**NATIONAL RAILROAD PASSENGER CORPORATION
NORTHEAST CORRIDOR
NEW YORK - WASHINGTON
SUMMARY BULLETIN ORDER No. NYW1-27SUM
Effective 12:01 AM, Monday, April 6, 2026**

INDEX OF RULE / SI CHANGES OR MODIFICATIONS CONTAINED IN THIS BULLETIN ORDER

I. Station Page

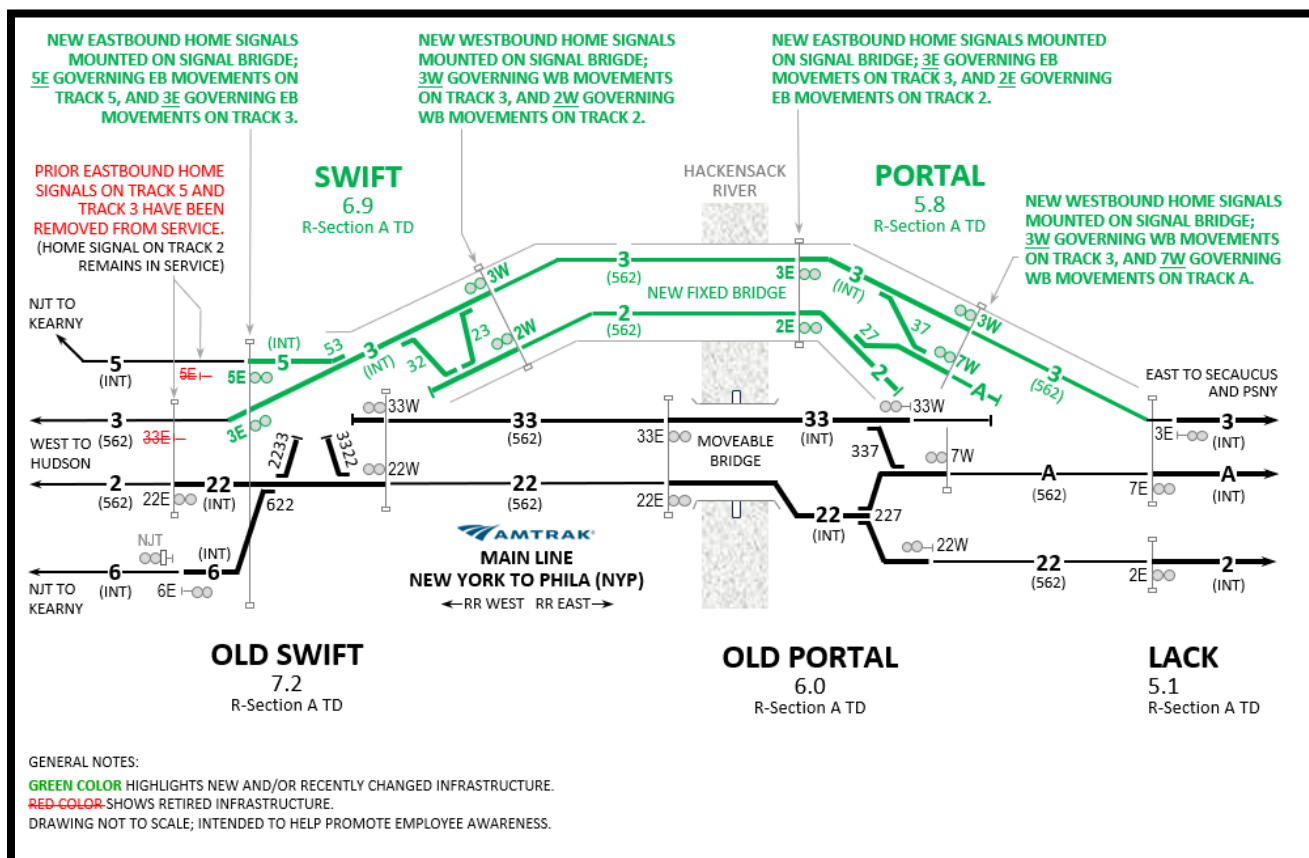
The Station Page is modified.

New Interlockings Portal & Swift are added.

277-N3 has been modified.

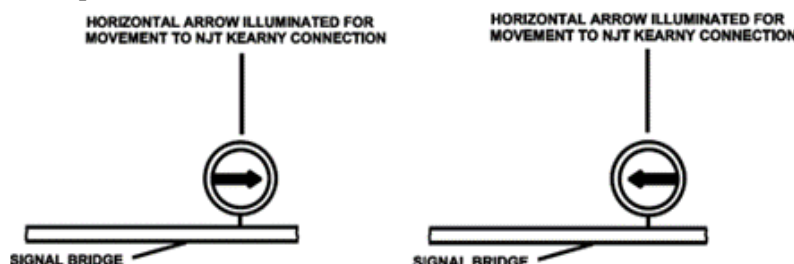
Old Swift has directional arrows in service for diverging moves from No. 22 Trk to No. 6 Trk.

White directional indicator arrows are in service for westward movements on No. 22 tracks at MP 6.3 and home signals at Swift.

1. No. 1 Track

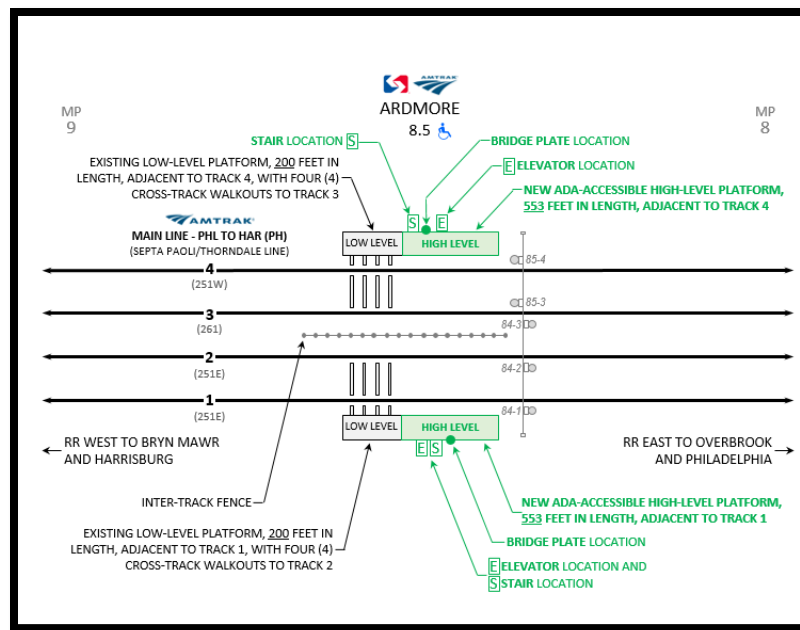
The station platform on No. 1 track at Ardmore Station has been reconstructed. The platform is high-level and 553' in length.

ADA bridge plate is located 156 feet east of the elevator.
